July 21, 2000
NSBU-NRC-00-5975

Subject: "Westinghouse Improved Performance Analysis and Design Model (PAD 4.0)," WCAP-15063-P-A, Revision 1, with Errata (Proprietary) and WCAP-15064-NP-A, Revision 1, with Errata (Non-Proprietary).

Figure 7-1

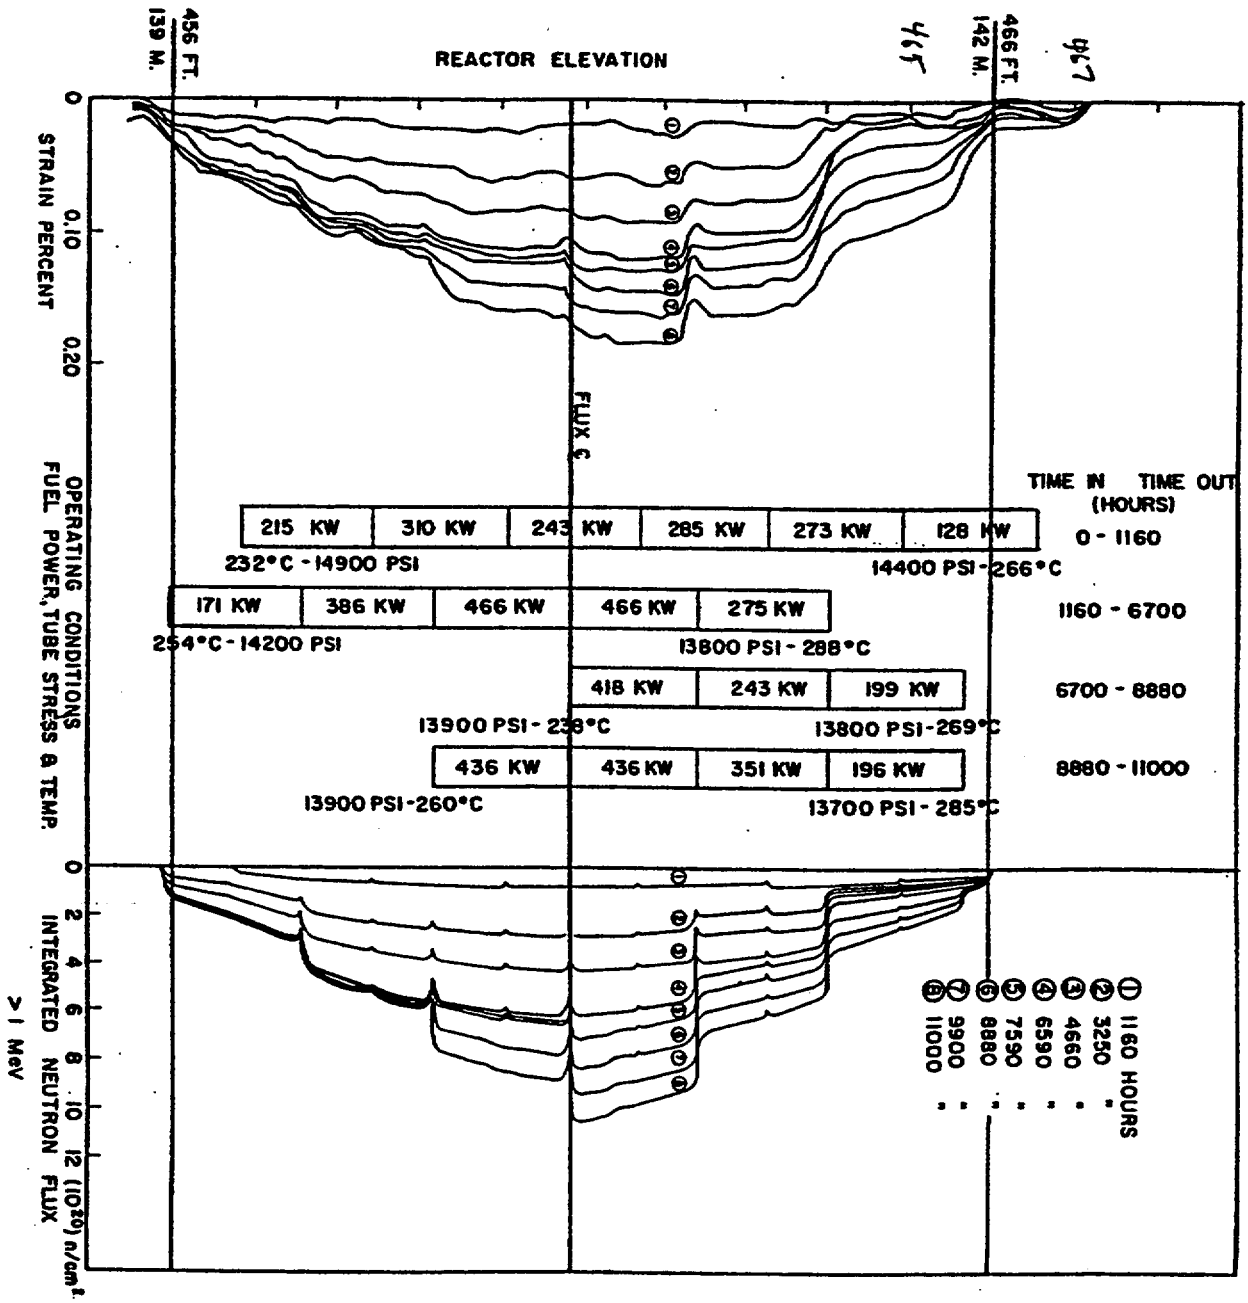
Question 8: **The data used to determine the coefficients to the Westinghouse creep-model for Imp Zr-4 and ZIRLO™ are based on creep due to compressive stresses while the internal rod pressure analysis at end-of-life calculates creep due to tensile stresses. Please provide cold-worked Zr-2 or Zr-4 tube data that demonstrates that compressive in-reactor creep data can be used to predict in-reactor creep under tensile stresses.**
